**IMPORTANT NONCOMPLIANCE RECALL**  
**NHTSA Recall 19V-064**

### *Incorrect Odometer Display Noncompliance Recall 19V-064*

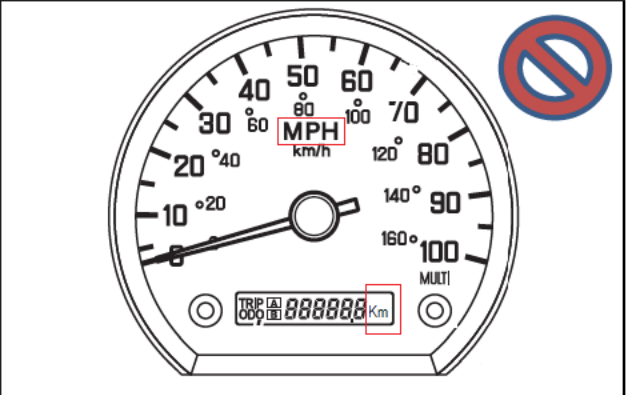
Inspect the odometer LCD on your vehicle. If the distance traveled indicates “mi” miles, the display is correct. Please complete the odometer check postcard included with this letter and drop it in the mail to inform us of your inspection result. No additional action is required. If the distance traveled indicates “km” kilometers, the meter cluster must be replaced. If you prefer not to perform the inspection yourself or have completed the inspection and determined the meter cluster indicates “km” kilometers, please contact your Isuzu dealer to schedule an appointment to have the meter cluster replaced **free of charge**. Although not necessary, please present this Owner Notification Letter at the time of your appointment or refer to Campaign Bulletin CB19-N-001A. Isuzu estimates that the repair will take approximately 24 minutes to perform, but additional time may be necessary. To locate the nearest Isuzu dealer you can visit our website at [www.isuzucv.com](http://www.isuzucv.com), click on the dealer locator link and enter your zip code or state. If you do not have access to a computer terminal please contact our Customer Relations Department at the number listed below.

USA OK Speedometer/Odometer  
MPH = "mi"

USA Noncompliance  
Speedometer/Odometer  
MPH ≠ Km

An Isuzu dealer will inspect and if necessary replace the meter cluster with one that has an odometer LCD that indicates “mi” (miles). The new odometer will be reprogrammed to reflect the number of miles traveled that was indicated on the original odometer. This service will be performed **free of charge**.
